Commonwealth Edison Company  
Byron/Braidwood Units 1 and 2  
Relaxation of MSSV Setpoint Tolerance to +/-3% - Revised SECL

Enclosed please find Revision 1 to safety evaluation SECL 90-469, previously transmitted via Reference 1. The revised safety evaluation clarifies the section of the ASME code associated with the main steam safety valves.

WESTINGHOUSE NUCLEAR SAFETY  
SAFETY EVALUATION CHECK LIST

APPENDIX B  
UFSAR MARKUPS

FIGURE 15.2-7

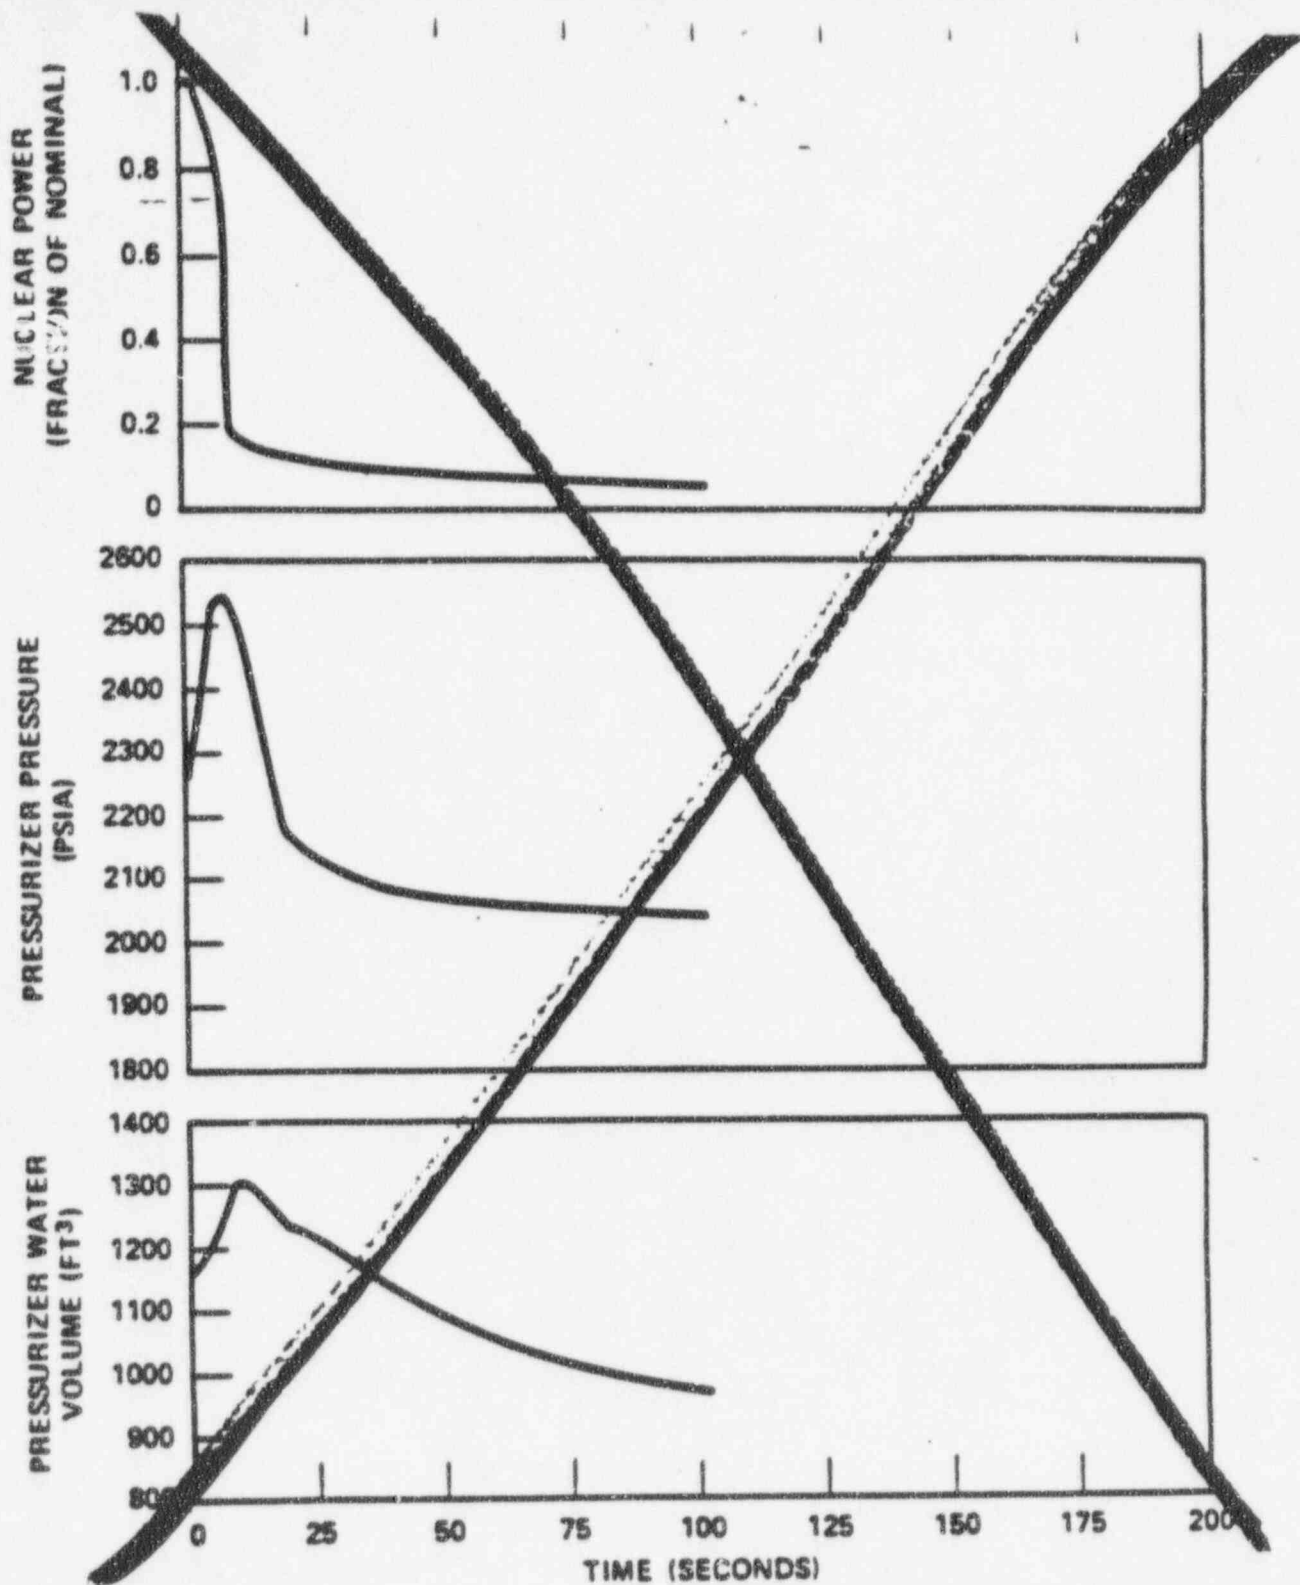
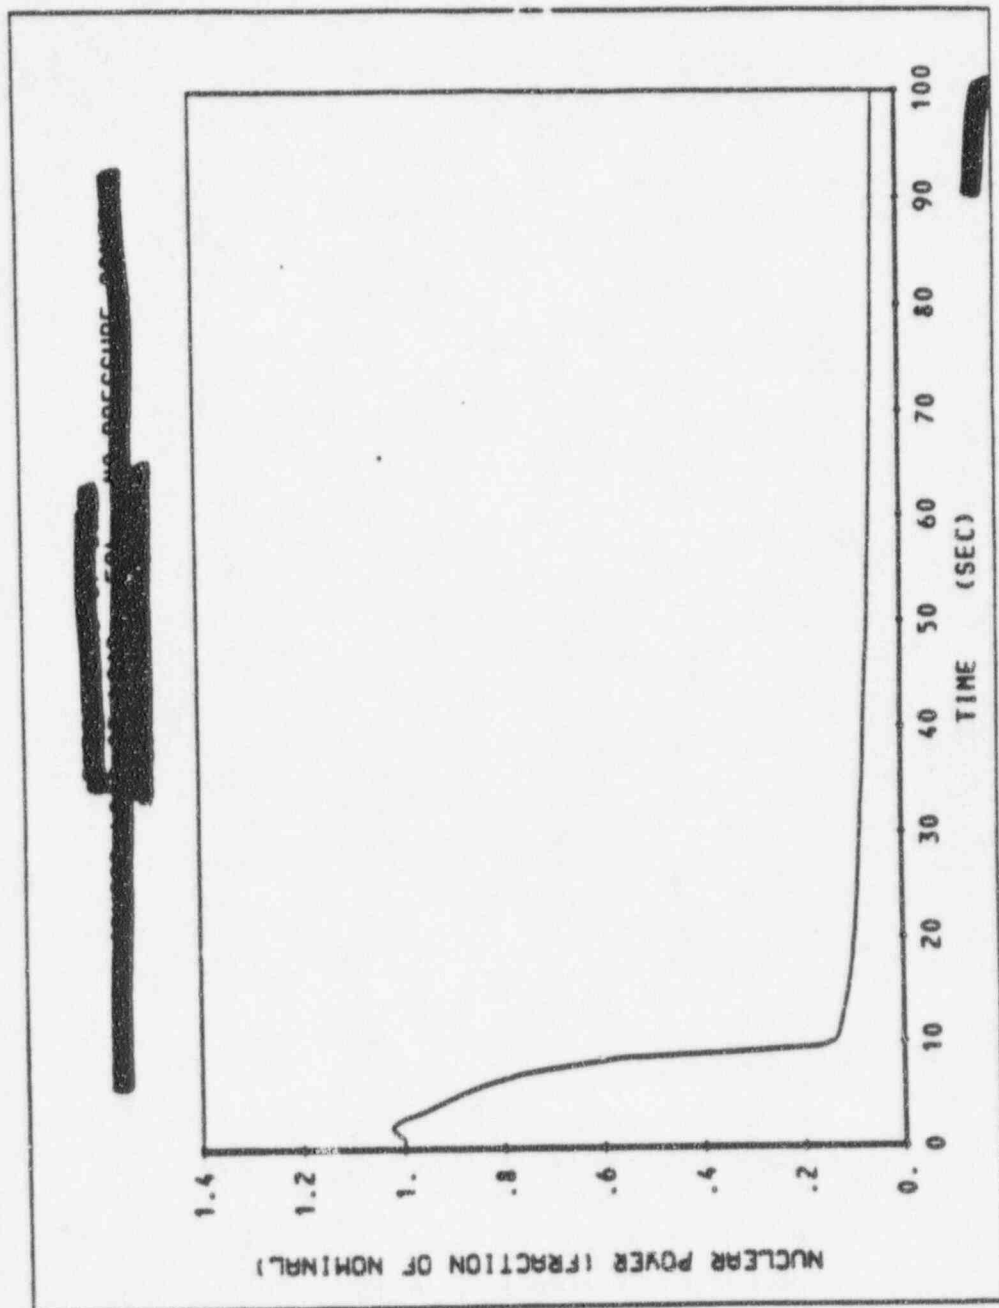
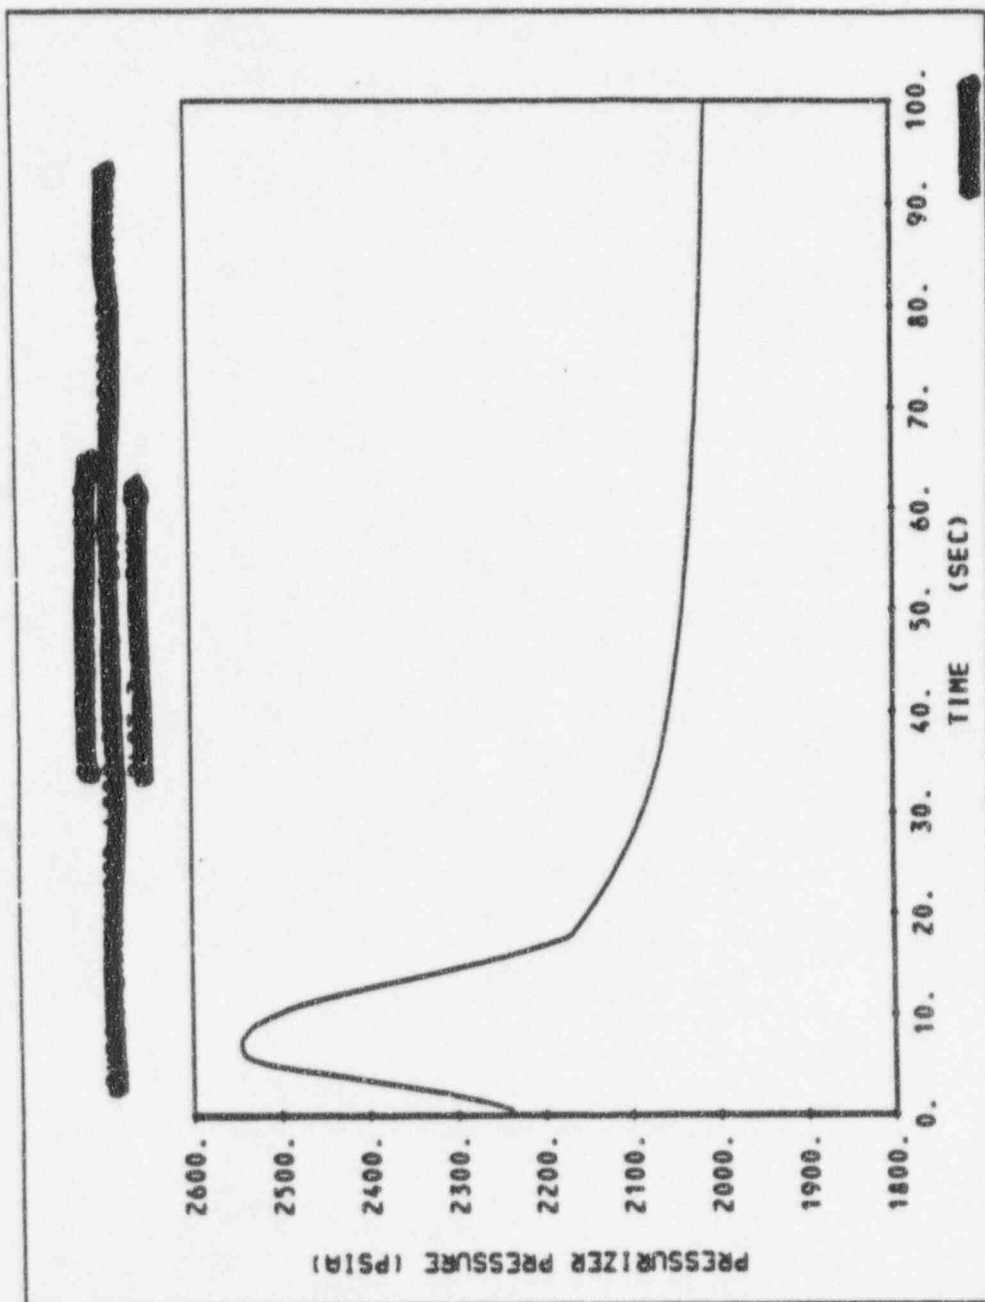
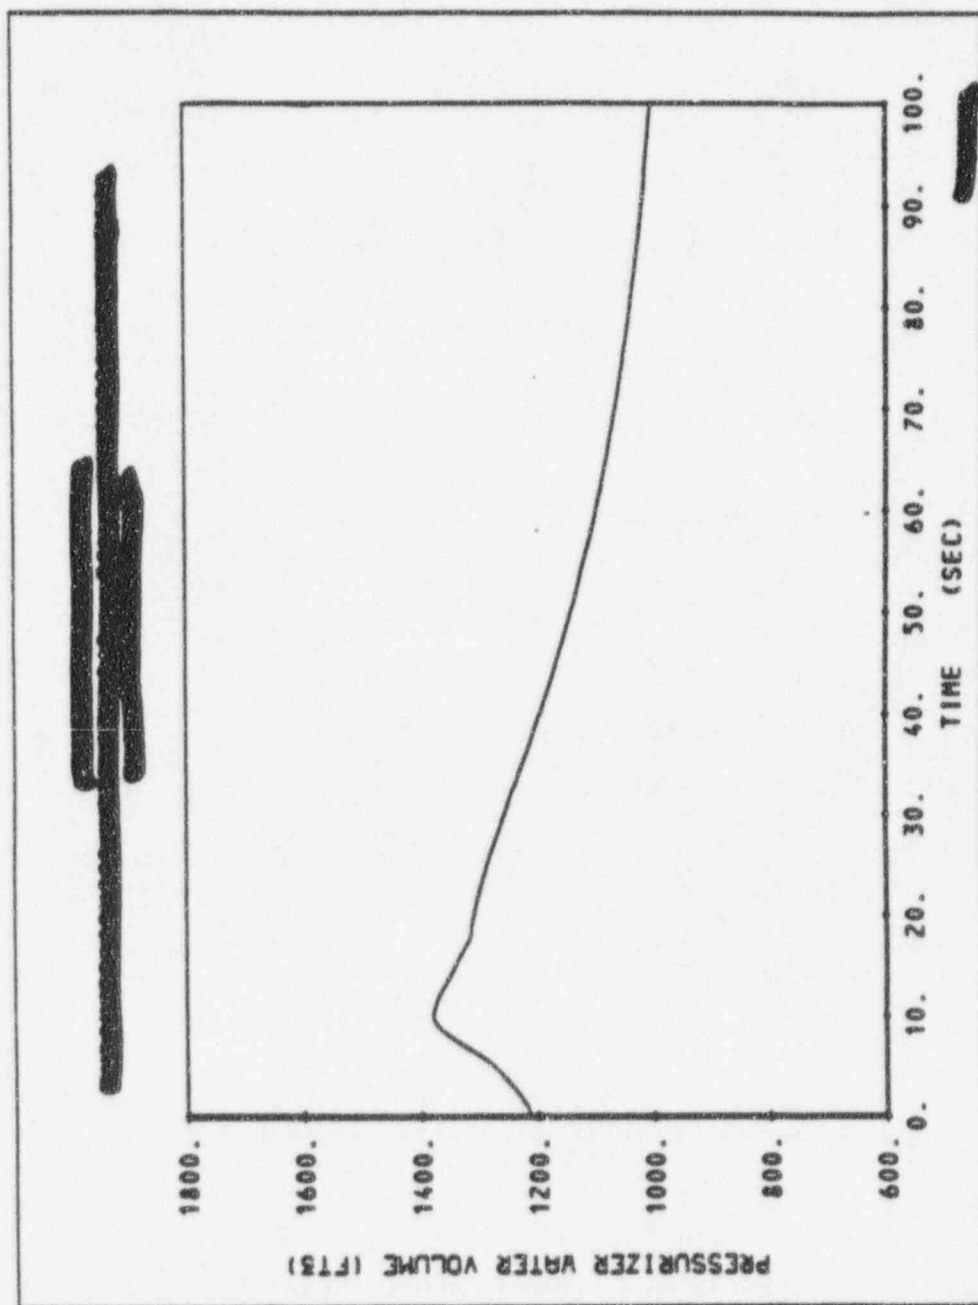
REPLACE WITH  
The following  
Figures
